STATE OF NEVADA

Department of Conservation & Natural Resources
DIVISION OF ENVIRONMENTAL PROTECTION

Re: **Tronox LLC (TRX)**
NDEP Facility ID #H-000539
Nevada Division of Environmental Protection Response to: *Phase 2 Sampling and Analysis Plan to Conduct Soil Characterization, Tronox Parcels "A" and "B" Site, Henderson, Nevada* dated August 14, 2007

Re: **Tronox LLC (TRX)**
NDEP Facility ID #H-000539
Nevada Division of Environmental Protection Response to: *Phase 2 Sampling and Analysis Plan to Conduct Soil Characterization, Tronox Parcels "A" and "B" Site, Henderson, Nevada dated July 24, 2007*

Comparison of Phase A and Background Data
B in Shallow Soils (up to 20 ft)

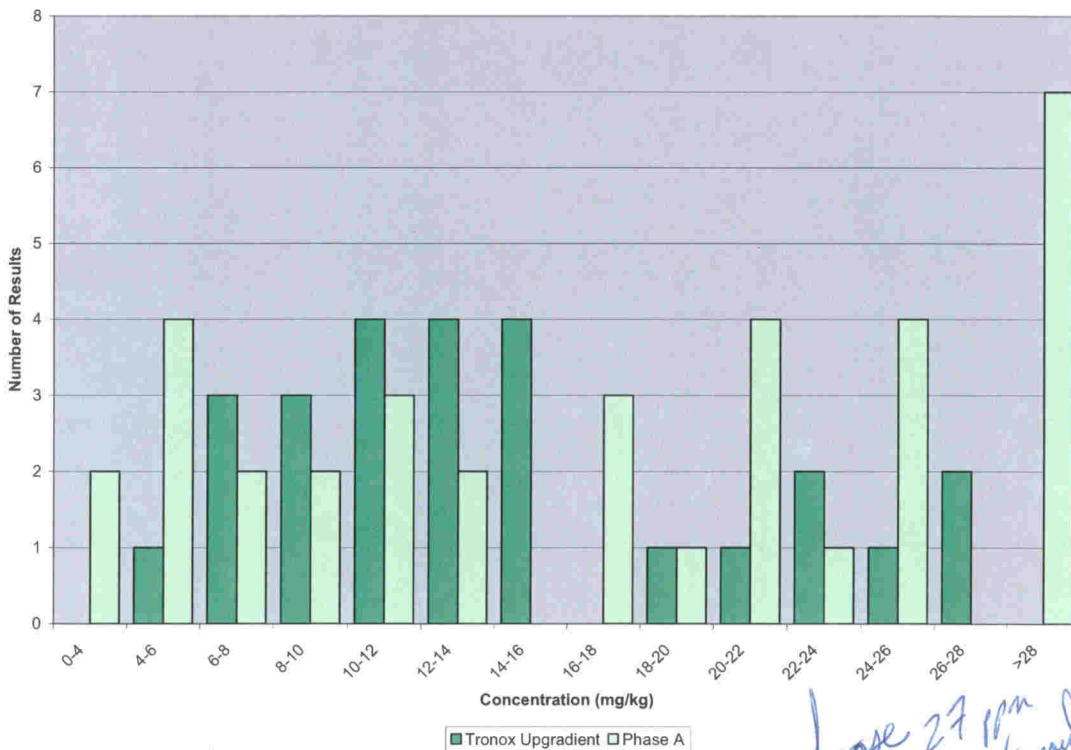
← comparing 20 ft & 10ft data
NDEL: either explain in text or remove from fig

Comparison of Phase A and Background Data
B in Deep Soils (> 20 ft)

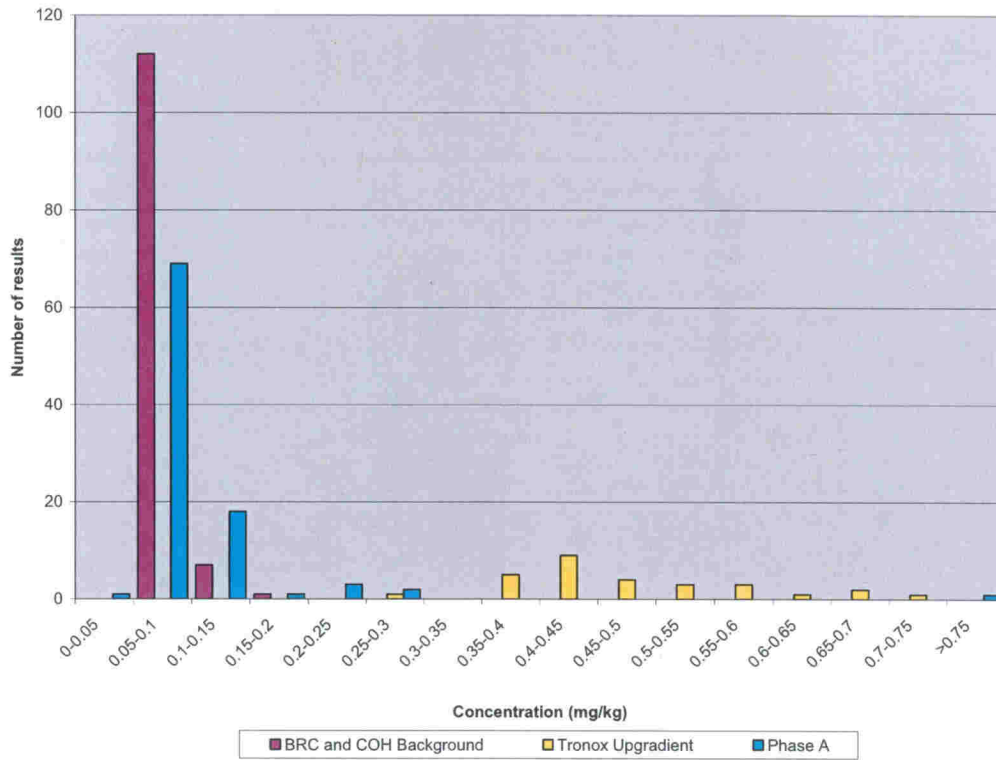
Choose 27 ppm for background.

Figure 1

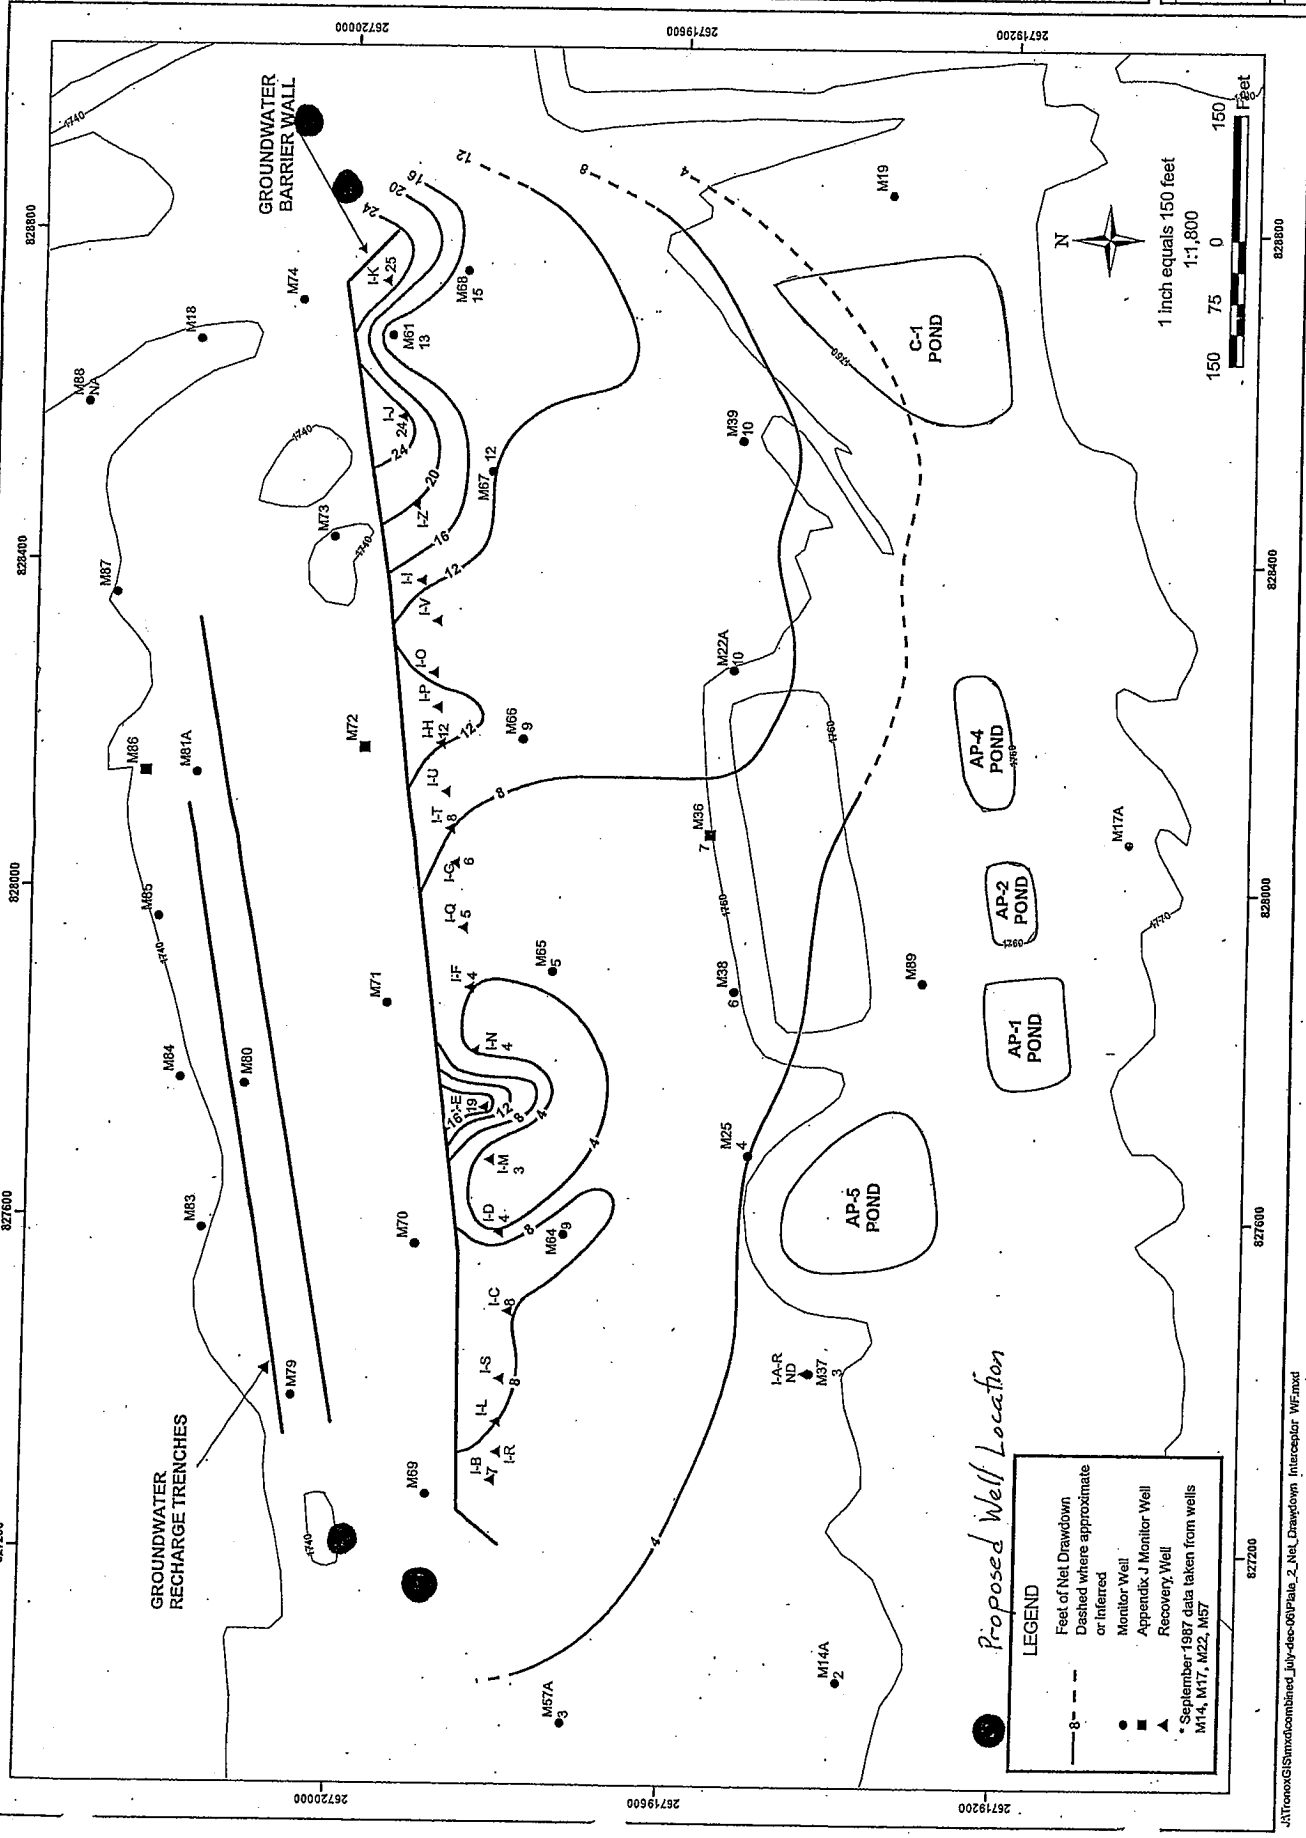
- a. The NDEP requests that this statement be supported with the installation of at least two monitoring wells at both locations as illustrated in Figure 1 (see following comment) to measure gradient. Flow may then be calculated using these newly installed monitoring wells and M69 (west side) and M74 (east side).

- b. Please note that the NDEP is including Figure 1 as example of possible well locations for comment clarity. TRX may propose different well locations.
